FINAL DRAINAGE REPORT FOR COLORADO CENTRE METROPOLITAN DISTRICT ADMINISTRATION BUILDING

PCD File # PPR-21-51

October 2022

DETENTION BASIN OUTLET STRUCTURE DESIGN

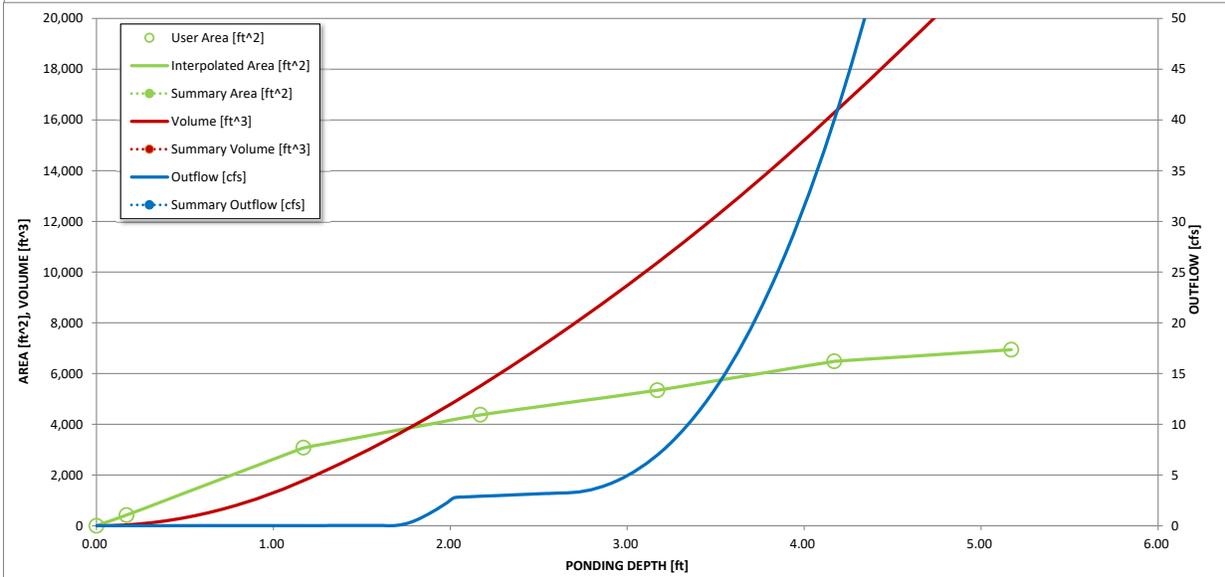
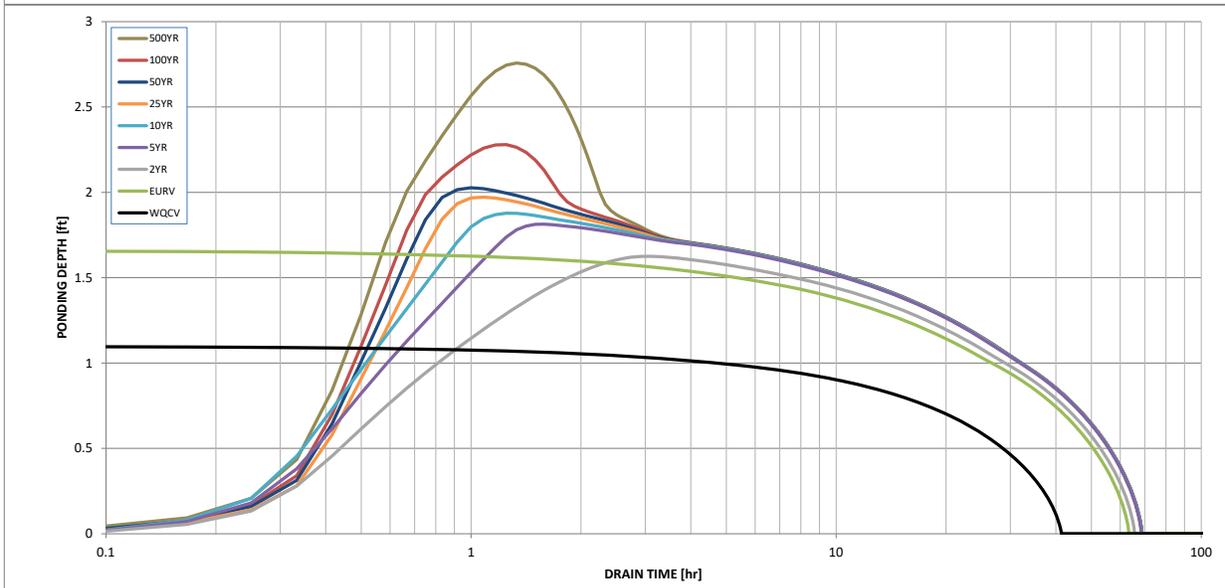
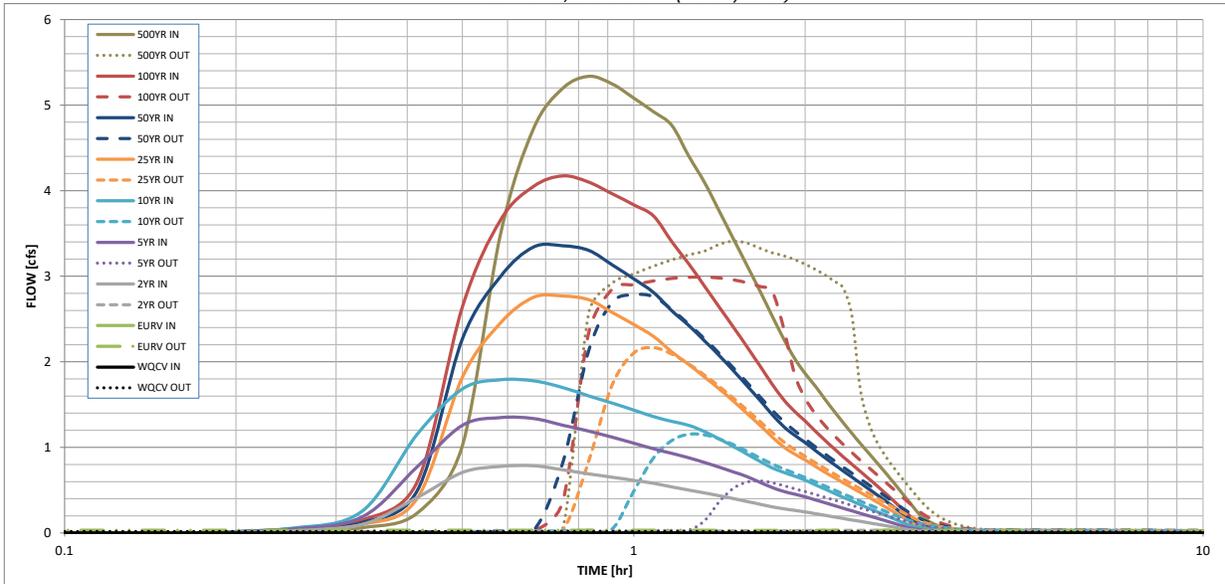
update

Manning Formula: Pond Inlet Channel - 5 Year Flow

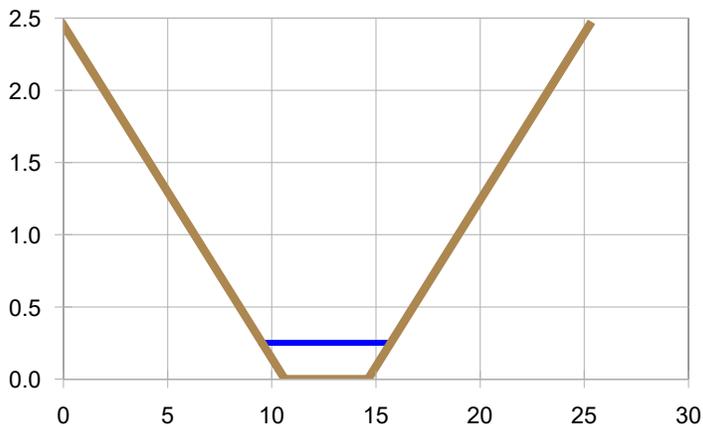
permanent check dams do not seem necessary with flows like this. please explain why rock checks are proposed

Update the section or the grading plan to match. The grading plan shows a v-ditch channel.
